TOWN OF GLASTONBURY  
GL-2020-19  
WELLES-TURNER MEMORIAL LIBRARY RENOVATIONS AND ADDITION PROJECT  
ADDENDUM NO. 2  
10/5/2020

**III. Revisions to the Drawings**

1. Replace the following drawings in their entirety:  
CS501, A2.01, A2.02, A11.01, M5.00
2. Revise the following drawings per Addendum 01, see attachment 1.  
SKA-006, SKA-007

**A2.01**

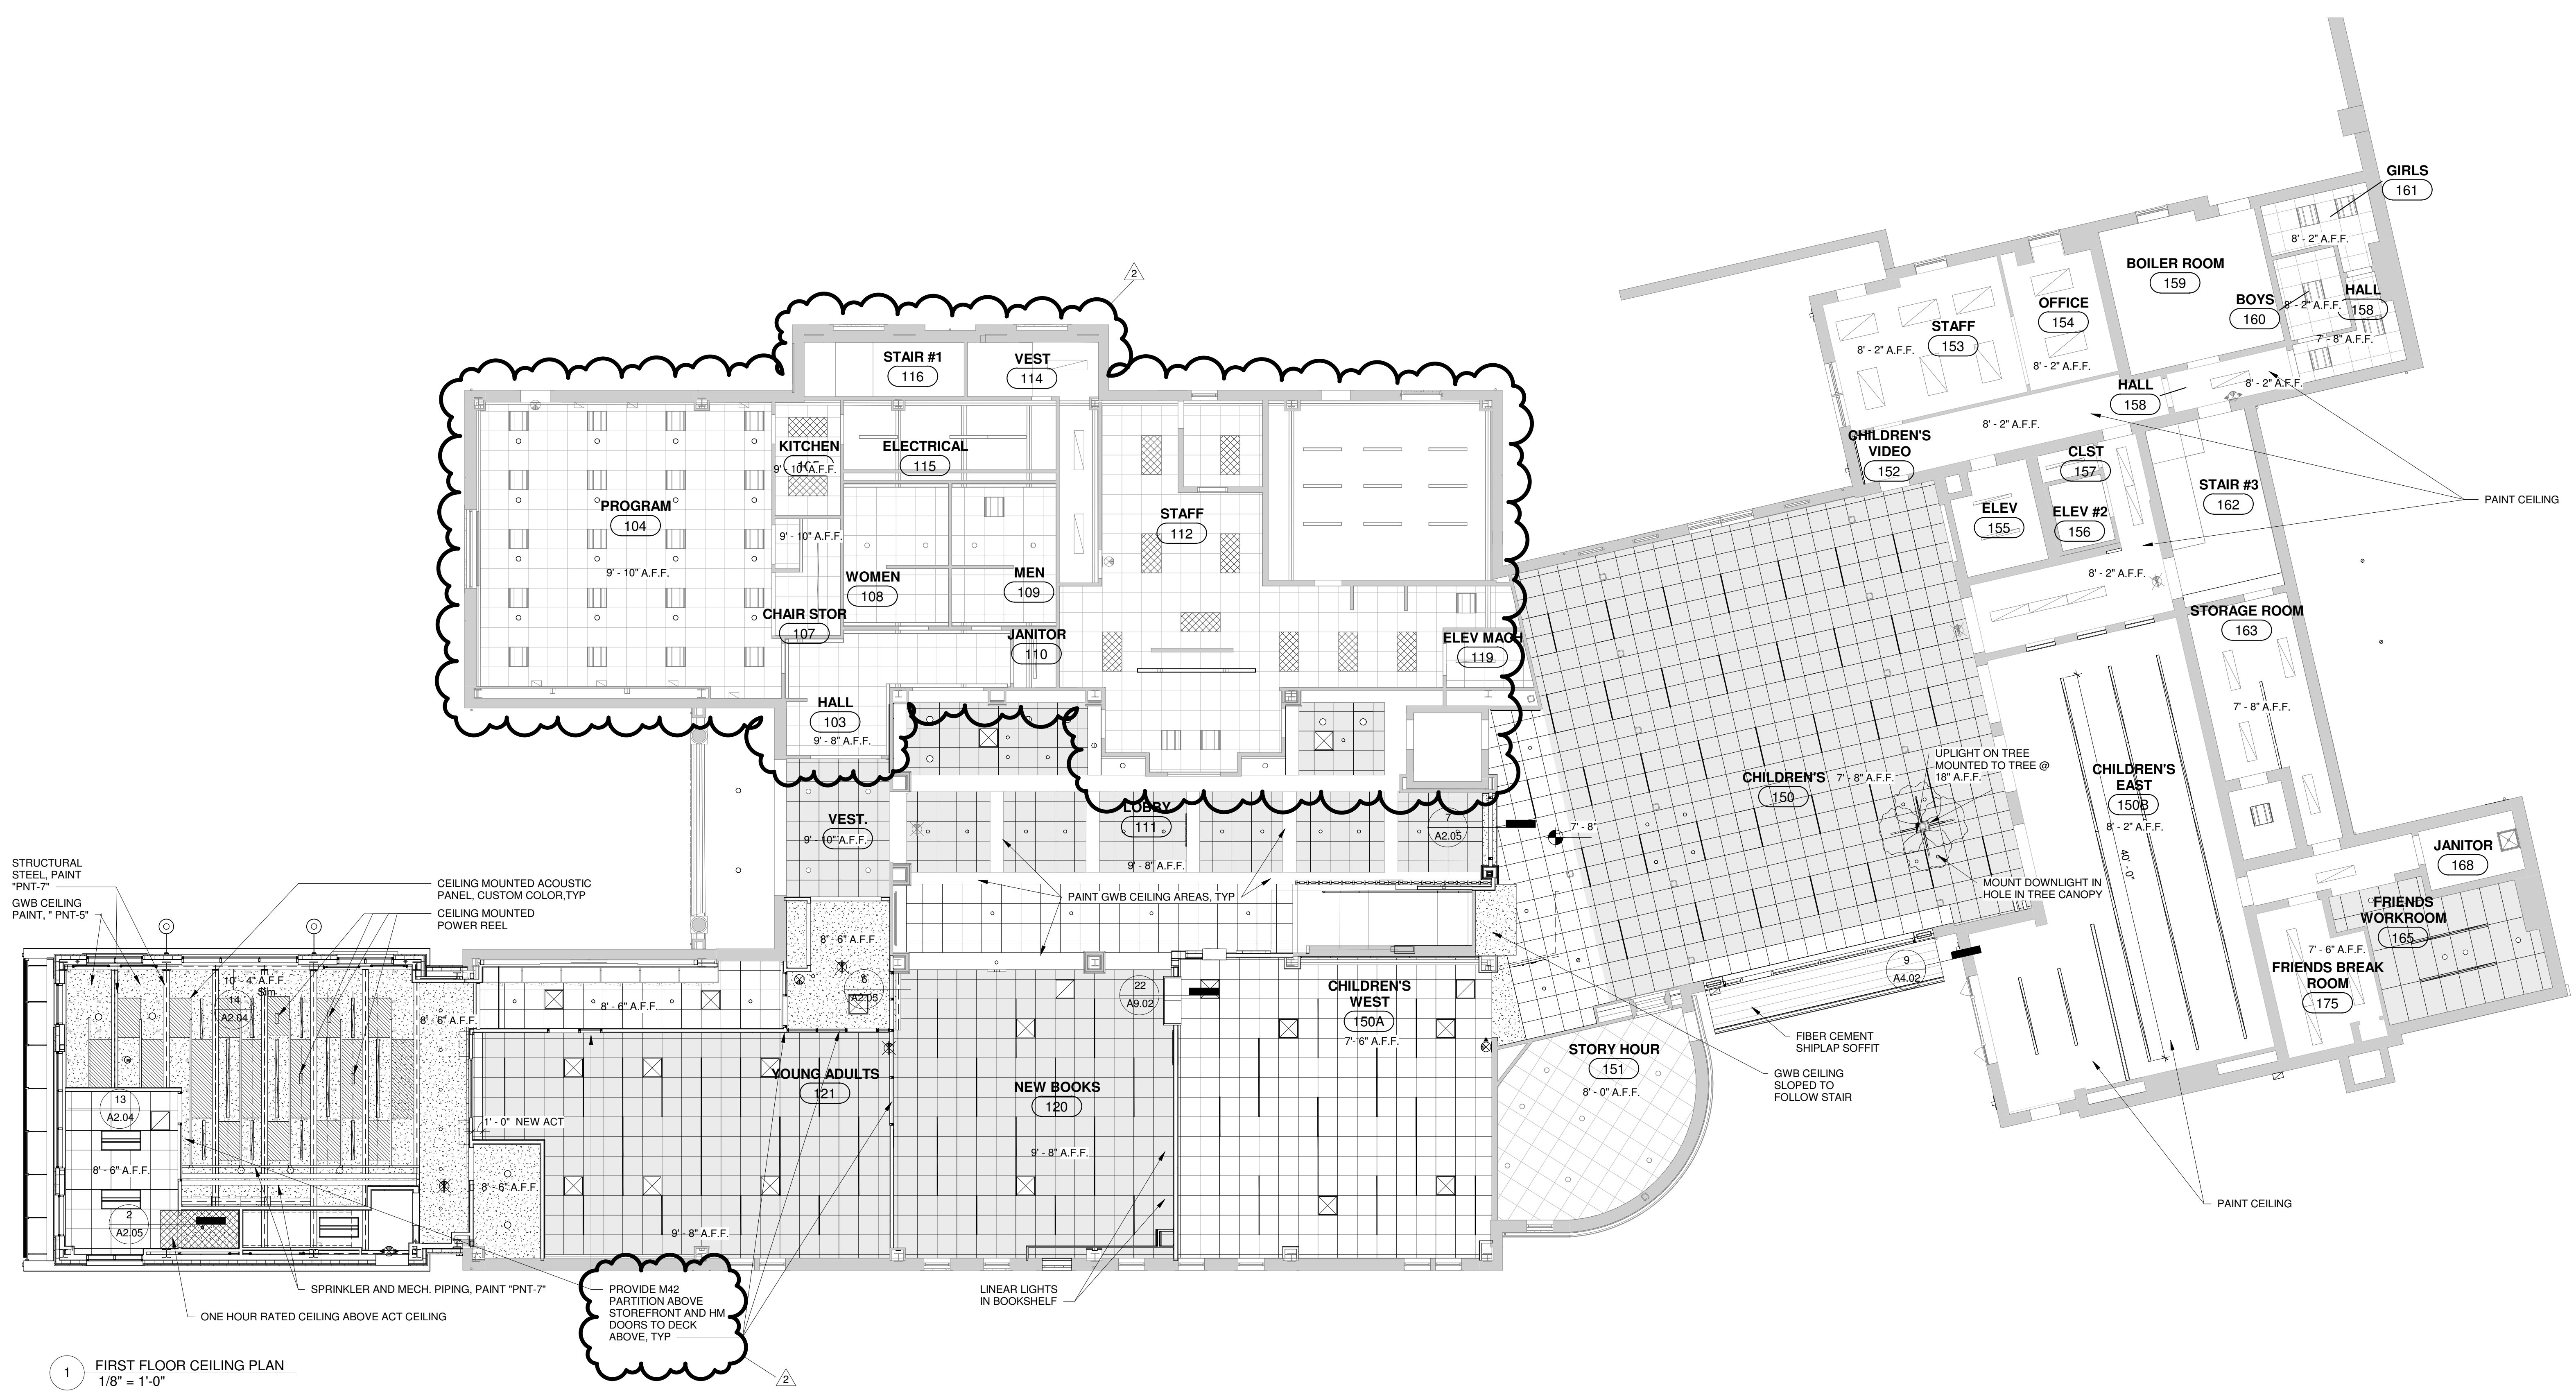
**Question 14:** *The legend on the reflected ceiling plans show the same white grid pattern for both 'Existing Ceilings to Remain' as well as 'New ACT Ceilings'. Please revise to eliminate confusion.*

**Answer:** The first floor reflected ceiling plan has been revised to more clearly distinguish new vs. existing ceiling grids. See Addendum #2.

**A2.02**

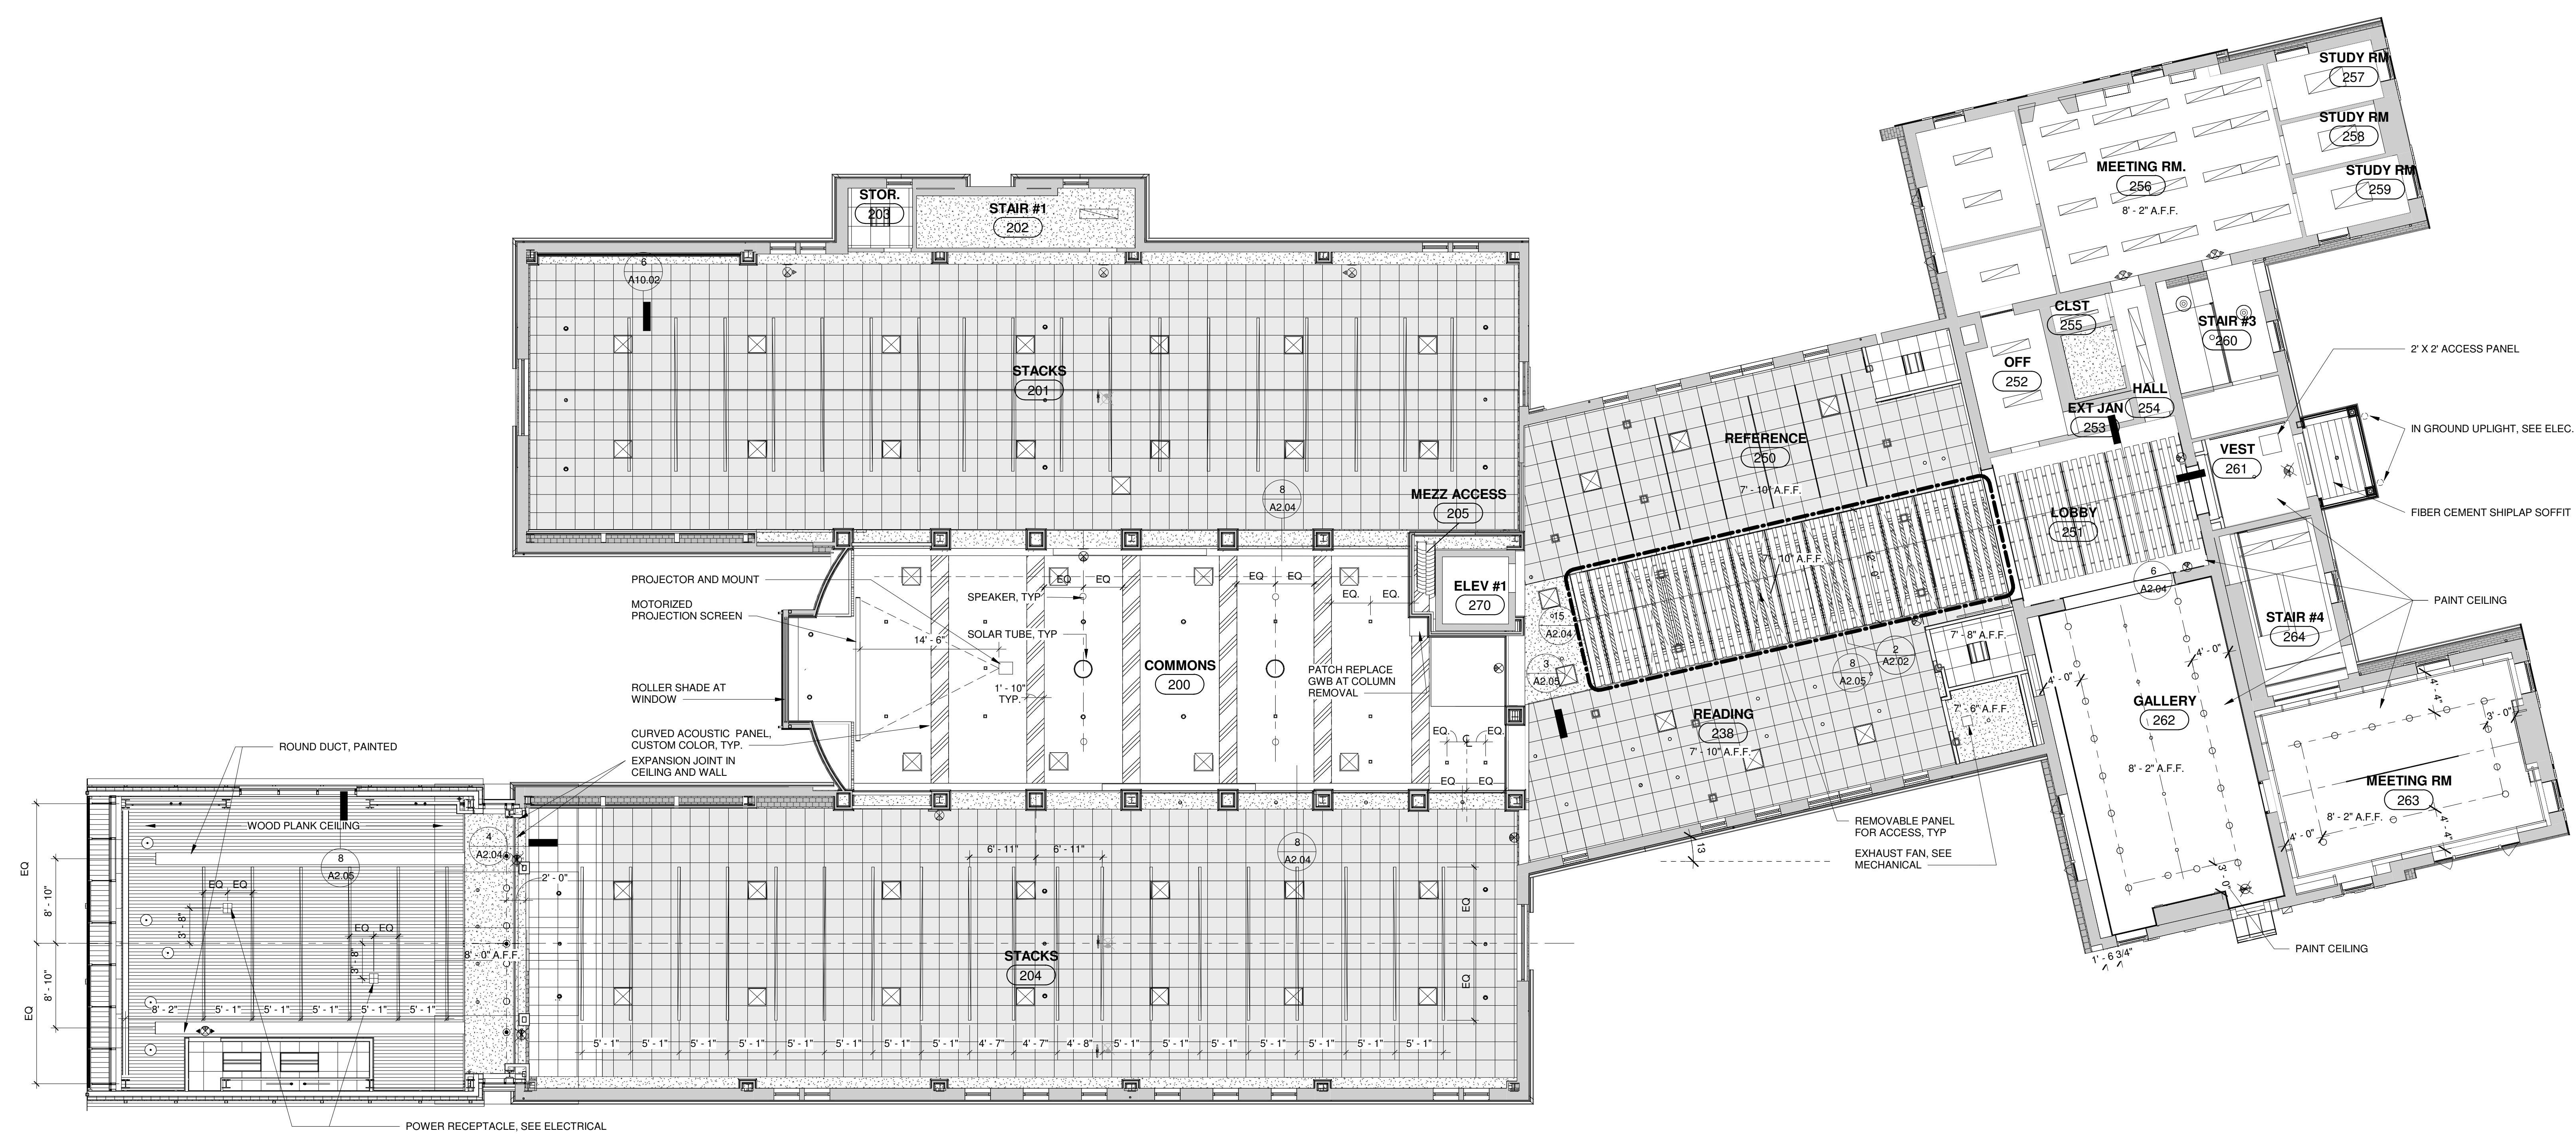
**Question 15:** *A-2.02 2nd floor reflected ceiling plan calls for wood plank ceiling in the addition but the texture in the space is for Curved Acoustic Panel according to the Legend. Please advise.*

**Answer:** The second floor reflected ceiling plan has been revised to more clearly distinguish the wood plank and curved acoustical panel ceilings. See Addendum #2.
